Vernon Hills Park District Turtle Creek Water Park

ADDENDUM 1

Re: Addendum #1 for Turtle Creek Water Park

Below are written descriptions of revisions and clarifications for the Civil Engineering Documents prepared for the Turtle Creek Water Park project in Vernon Hills, Illinois.

C-1.0
SITE DEMOLITION PLAN

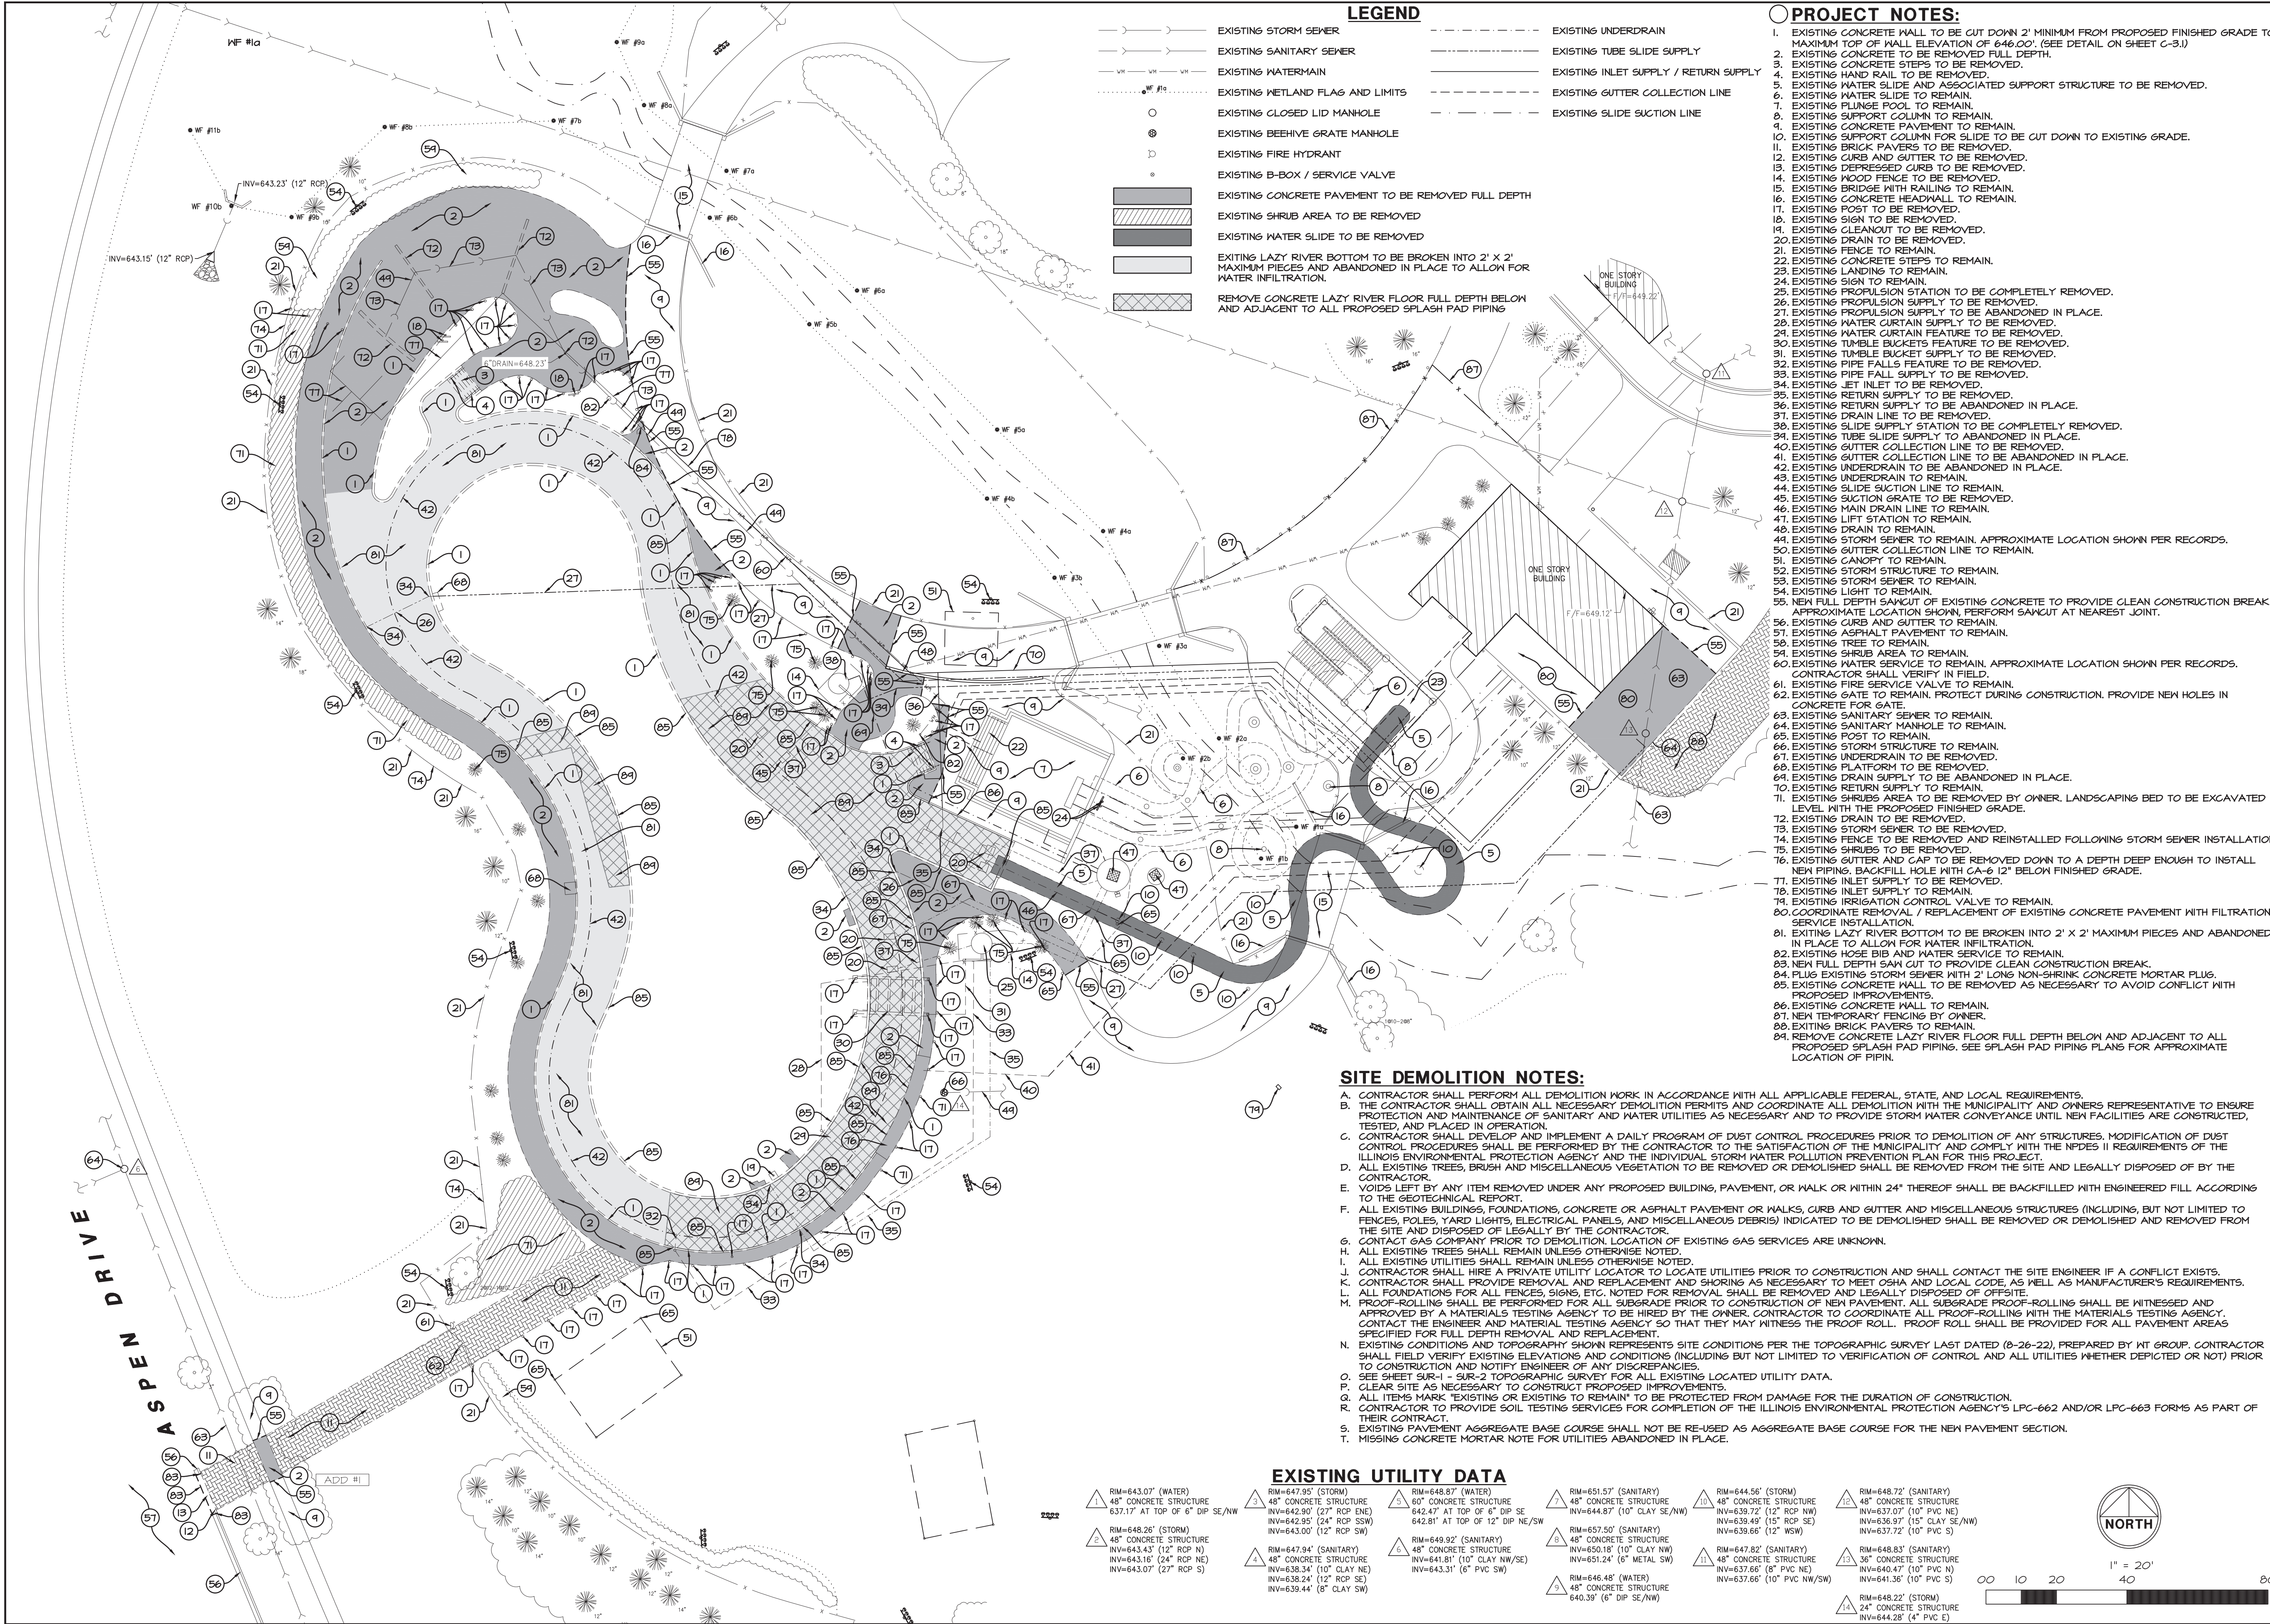
1. Removed section of existing sidewalk near Aspen Drive at crossing with the existing grass pavers.

C-2.0

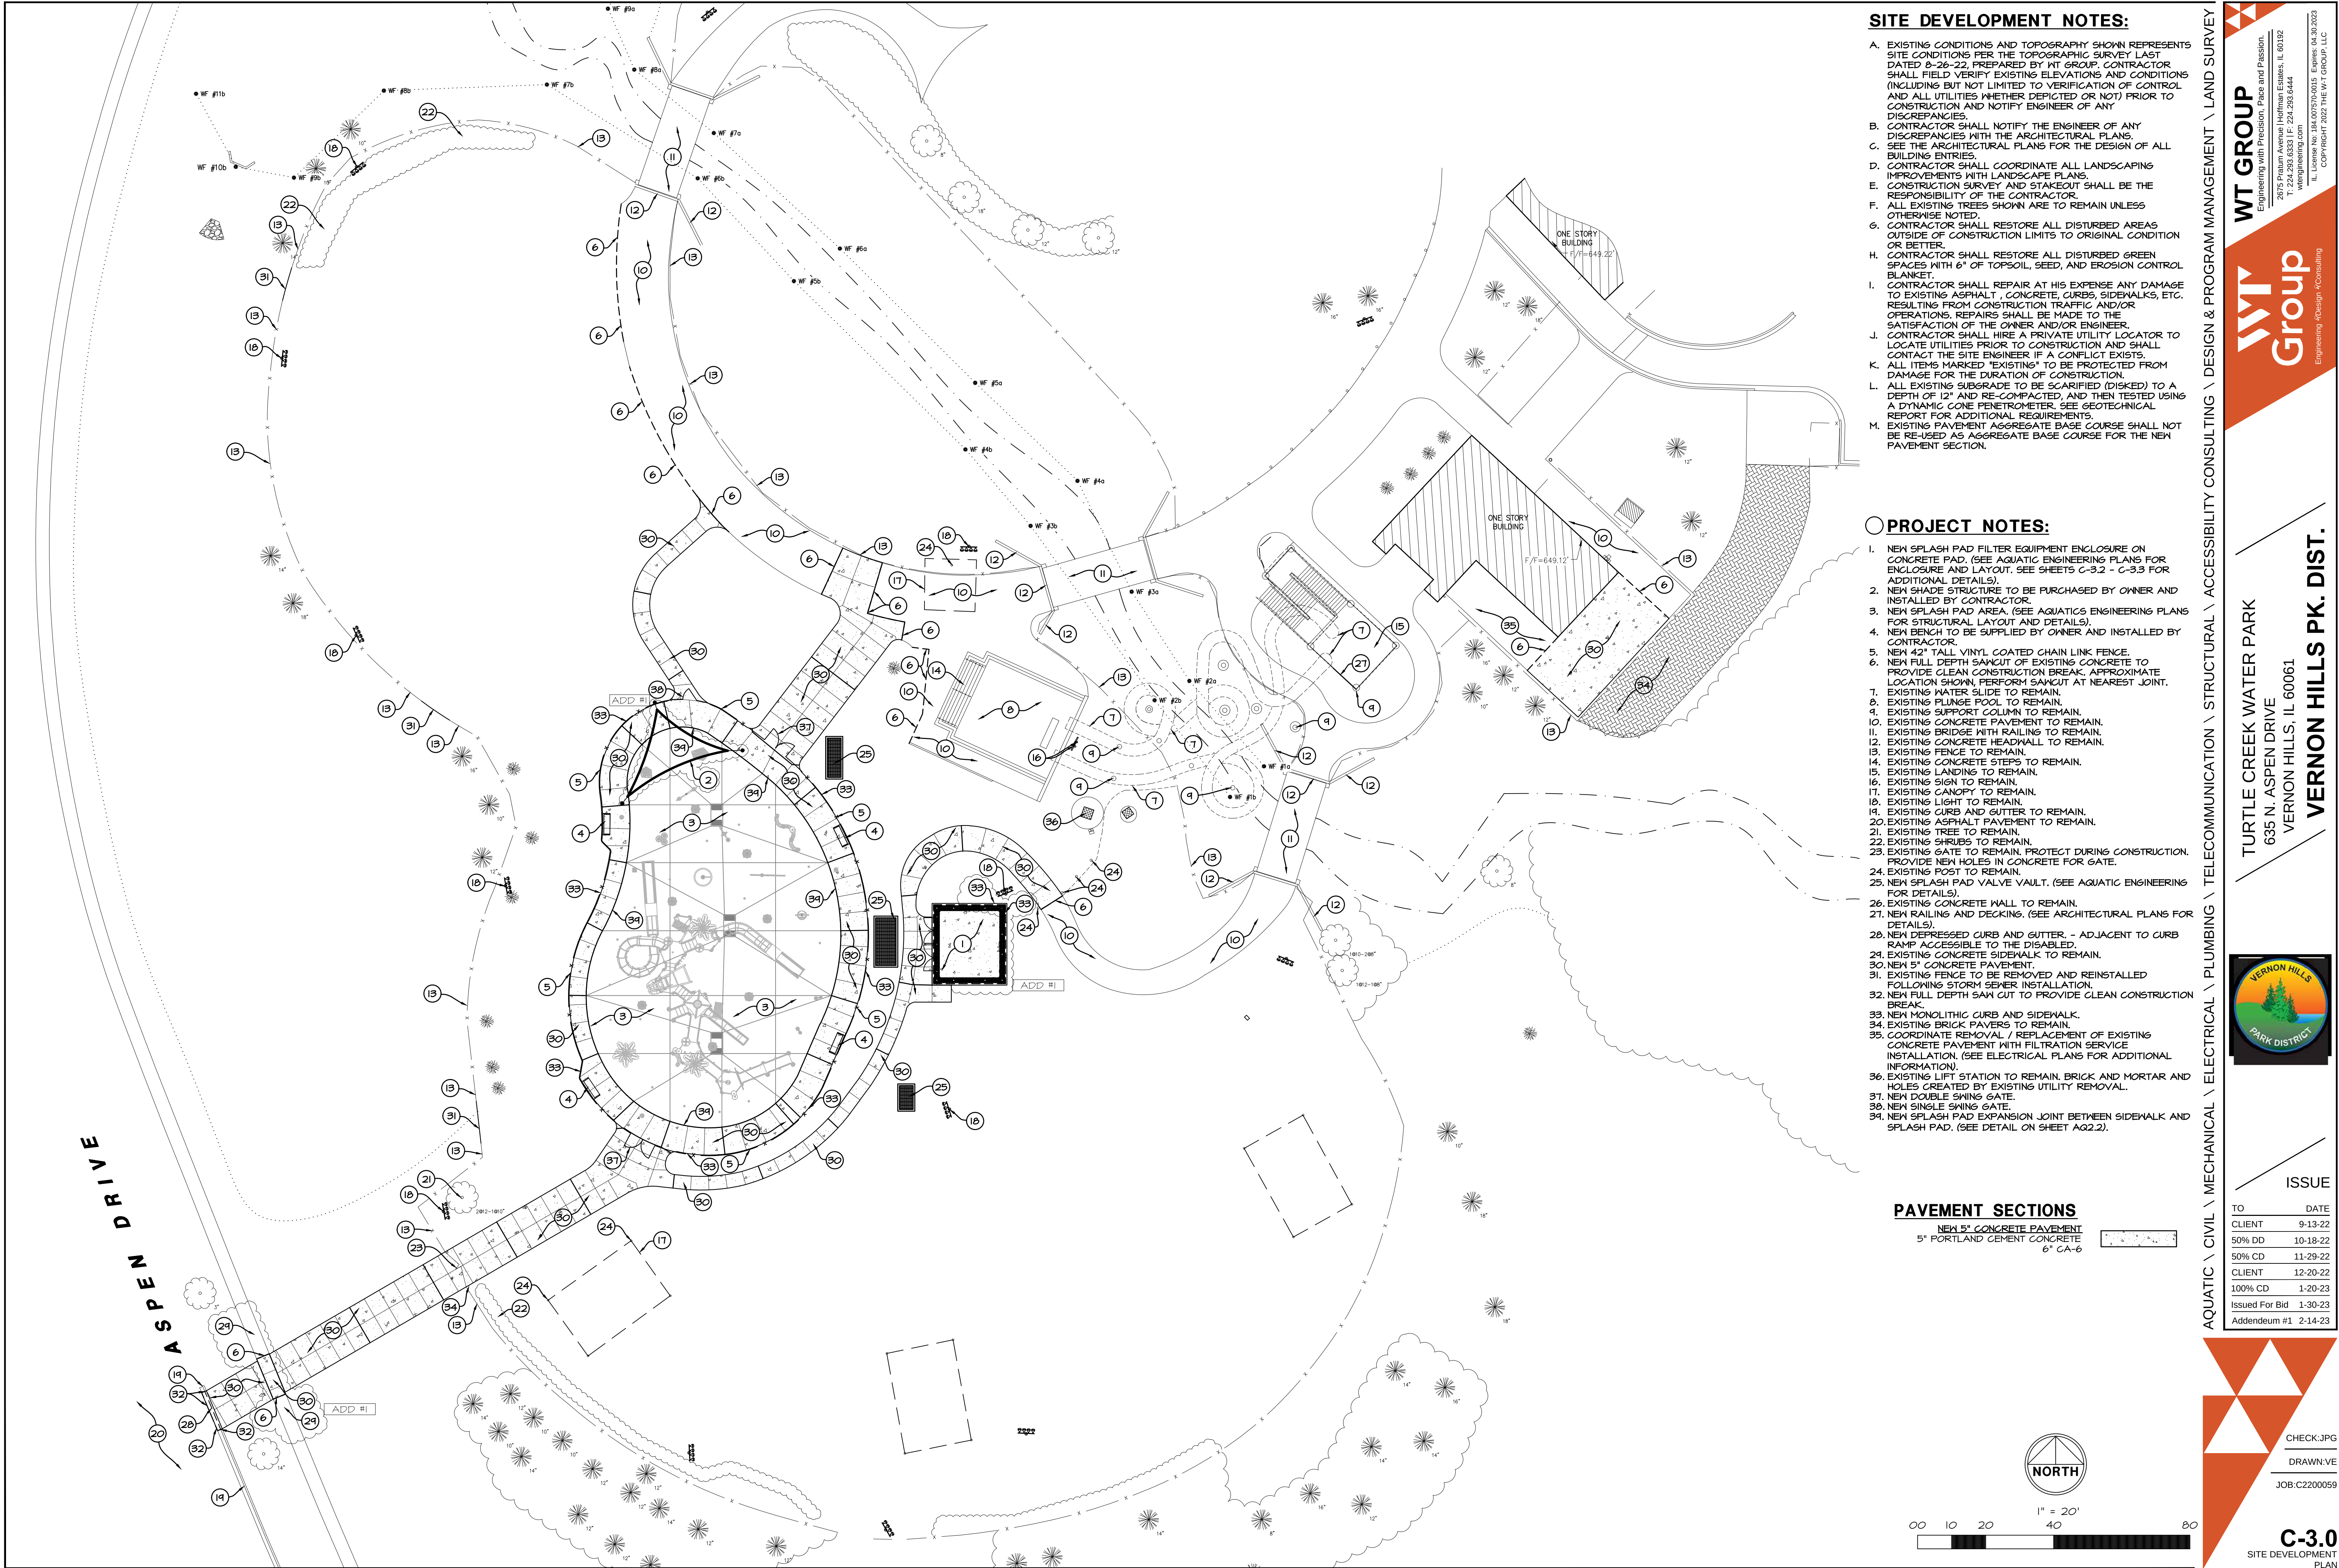
1. Replaced section of existing sidewalk near Aspen Drive at crossing with the existing grass pavers.
2. Adjusted location of the proposed shade structure to avoid conflicts between the foundations and the proposed splash pad.
3. Revised tags for monolithic curb and sidewalk adjacent to the proposed equipment enclosure. The proposed monolithic curb is intended to abut the northeast corner of the surge tank within the equipment enclosure, extend along the north edge of the enclosure to the northeast corner, and extend 5' down the east side of the enclosure to allow for an approximately 4" drop of the adjacent grade along the north side of the enclosure.
